THE ILLINOIS STATE TOLL HIGHWAY AUTHORITY

DESIGN BULLETIN No. 14-11

SUBJECT: MOMENT SLAB ON RETAINING WALL DESIGN GUIDES

MOMENT SLAB REINFORCEMENT FOR 13" MAINLINE PAVEMENT WITH 3" SUBBASE

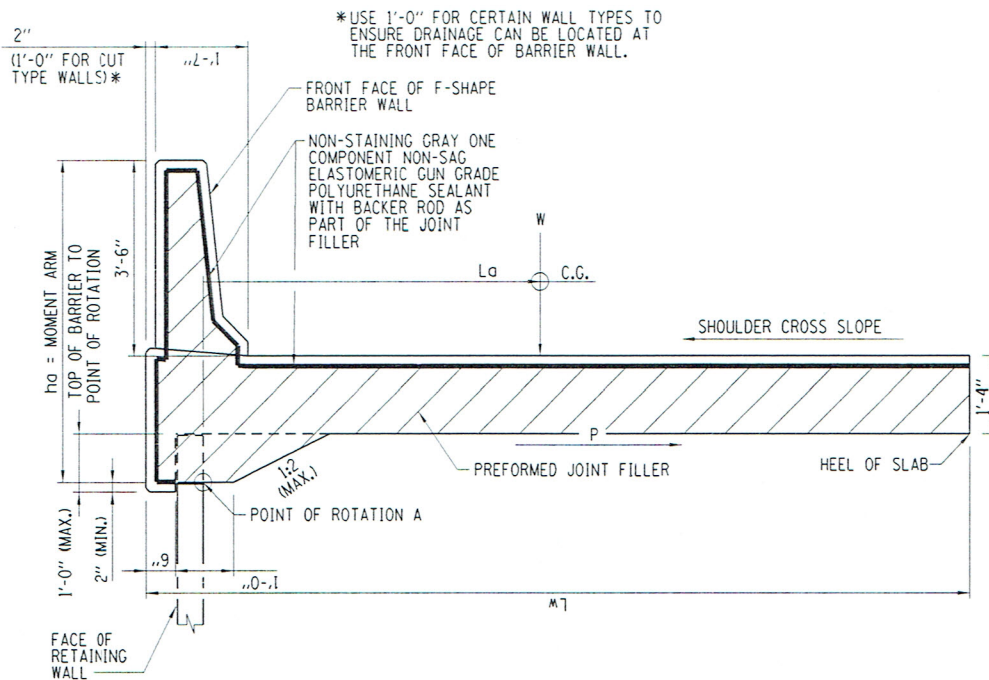
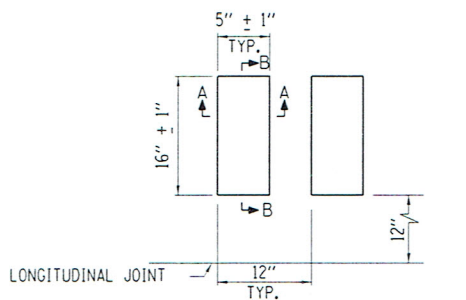
The Illinois Tollway has modified the design of the TL-5 moment slab for retaining wall to accommodate the I-90 typical 13" PCC mainline pavement section and provide additional protection of the moment slab reinforcement. The attached Figures A and B shall supersede the Figures 22.6.1 and 22.6.2 in the March 2014 Issue of the Tollway Structure Design Manual.
